DRAWING NO. D212-664-241	TITLE CROSSTUBE ASSY (205/212:HI AFT)	REV. D	DART AEROSPACE LTD ENGINEERING ORDER		D.E.O. NO. D212-664-241-D-1	SHEET NO. SHEET 1 OF 2	SCALE NTS
DRAWN	CHECKED	MFG. APPR.	APPROVED	DE APPR.			
DATE 11.04.07	DATE 11.04.11	DATE 11.04.12	DATE 11/04/12	DATE 11.04.12

ADD AN INSPECTION WINDOW TO UNDERSIDE OF CROSSTUBE.

DRAWING NO. D212-664-241	TITLE CROSSTUBE ASS'Y (205/212 HI AFT)	REV. D	DART AEROSPACE LTD ENGINEERING ORDER		D.E.O. NO. D212-664-241-D-2	SHEET NO. SHEET 1 OF 1	SCALE NTS
DRAWN 90	CHECKED ASS	MFG. APPR. 8	APPROVED MD		DE APPR. H		
DATE 11.07.15	DATE 11.07.20	DATE 11.07.21	DATE 11/27/21		DATE 11.07.21

REPLACE MAGNOBOND WITH PROSEAL.

**D212-664-241/-241B
ASSEMBLY DETAIL**

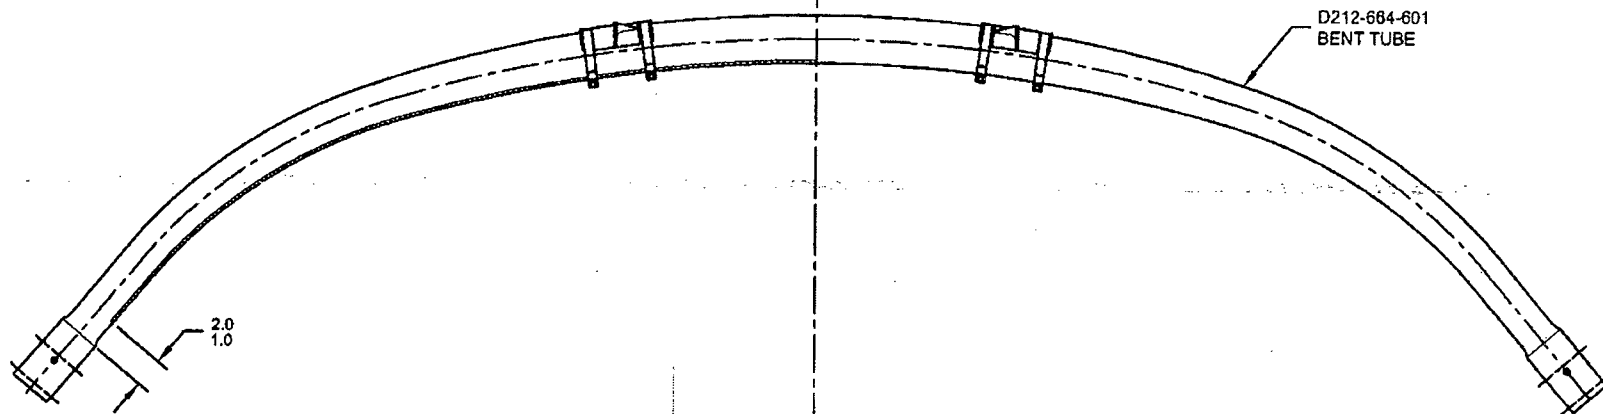
NOTES 2 OF SHEET 1 IS AMENDED AS FOLLOWS:

- 2) FINISH: CHEMICAL CONVERSION COAT PER DART QSI 005 4.1
PRIME INSIDE AND OUTSIDE PER DART QSI 005 4.2
MASK UNDERSIDE OF CROSSTUBE AS SHOWN (HATCHED AREA) AND
PAINT OUTSIDE PER DART QSI 005 4.2
REMOVE MASKING AND APPLY CLEAR COAT

MASK AREA PRIOR TO PAINTING,
REMOVE MASKING AFTER PAINT
AND APPLY CLEAR COAT
